Project	<b>IEEE 802.16 Broadband Wireless Access Working Group</b> < <a href="http://ieee802.org/16">http://ieee802.org/16</a> >	
Title	<b>Flow charts for MS Initial Ranging with Non-transparent RS (Distributed)</b>	
Date Submitted	<b>2007-07-05</b>	
Source(s)	Kanchei (Ken) Loa, Yi-Hsueh Tsai, Yung-Ting Lee, Hua-Chiang Yin, Shiann-Tsong Sheu, Youn-Tai Lee,  Institute for Information Industry 8F, No. 218, Sec. 2, Dunhua S. Rd., Taipei City 106, Taiwan  Masato Okuda  Fujitsu	Voice: +886-2-27399616 Fax: +886-2-23782328 <a href="mailto:loa@nmi.iii.org.tw">loa@nmi.iii.org.tw</a>  <a href="mailto:okuda@jp.fujitsu.com">okuda@jp.fujitsu.com</a>
Re:	IEEE 802.16j-07/019: "Call for Technical Comments Regarding IEEE Project 802.16j"	
Abstract	This contribution proposes flow charts for MS Initial Ranging with Non-transparent RS	
Purpose	Text proposal for 802.16j Baseline Document.	
Notice	<i>This document does not represent the agreed views of the IEEE 802.16 Working Group or any of its subgroups. It represents only the views of the participants listed in the "Source(s)" field above. It is offered as a basis for discussion. It is not binding on the contributor(s), who reserve(s) the right to ad

**Figure 95i Handle CDMA Initial Ranging Code at Non-transparent RS**

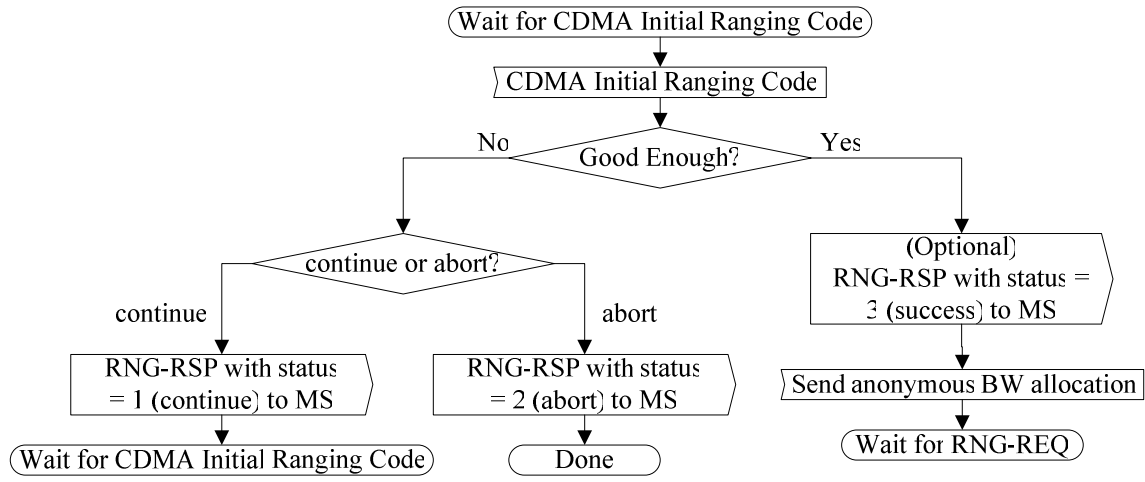
*[change subclause 6.3.9.16.2.2 in line 54 of page 85 as following index:]*

The message sequences charts (Table 199c and Table 199d) [and flow charts \(Figure 95i, Figure 95j, Figure 95k\)](#) on the following page defines the ranging and adjustment process that shall be followed by compliant RSs and MR-BSs. For CDMA ranging process between RS and MS, these details can be found in 6.3.10.3.

[Insert the following figures at the end of subclause 6.3.9.16.2.2:]
